Amendments to the Drawings:

REMARKS

Figs. 16-18 As Amended

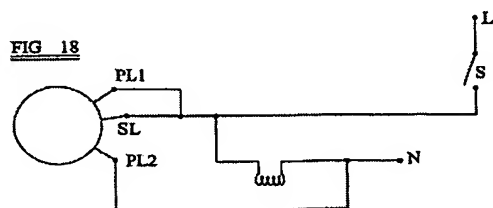
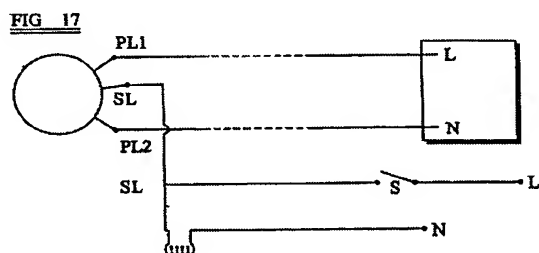
Figures 16-18 have been amended to correctly label the switch live terminal SL. Support for the amendment to Figs. 16-18 can be found, for example, in the specification at paragraphs [0150] to [0153].

For example, in Fig. 16, the second electrical connection SL is not connected, and the first electrical connection (PL1 to PL2) supplies external power to the alarm circuit. In Fig. 17, the second electrical connection SL is connected to the light side of the switch, however, the

first electrical connection supplies electrical connection to the alarm circuit independent of the second electrical connection, via a direct connection to the external live power. In Fig. 18, the light side of the switch is connected to both the first and second electrical connections PL1/SL, however, the first electrical connection PL1 provides power independent of whether or not the second electrical connection SL is complete.
